FIELD INSPECTION REPORT

Project Name:	Mountain Valley Pipeline	Inspector:	Justin Burch
Inspection Date:	Saturday, July 14, 2018	Project Contact:	Brian Clauto, Tracy Hilbun
Spread:	Spread I	Weather (Wet/Dry/Rain):	Dry

Fig. 2 Large Bore Pit partially excavated

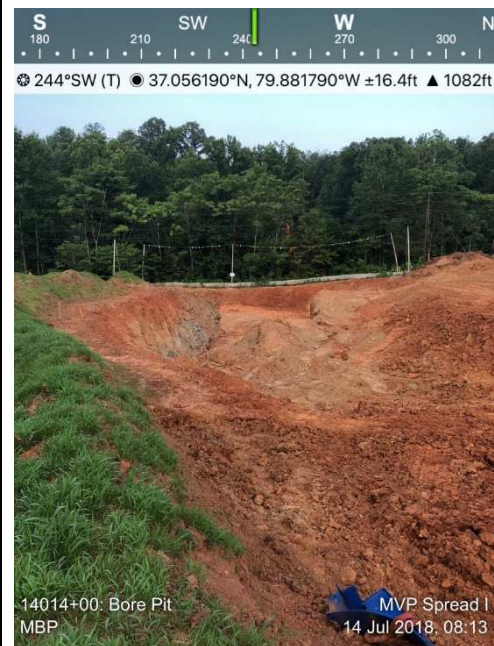
All controls were in place and in good condition with upgraded or additional measures with the exception that the three waterbars were mostly eliminated with large bore pit excavation. After the bore pit is backfilled three waterbars will be re-established.
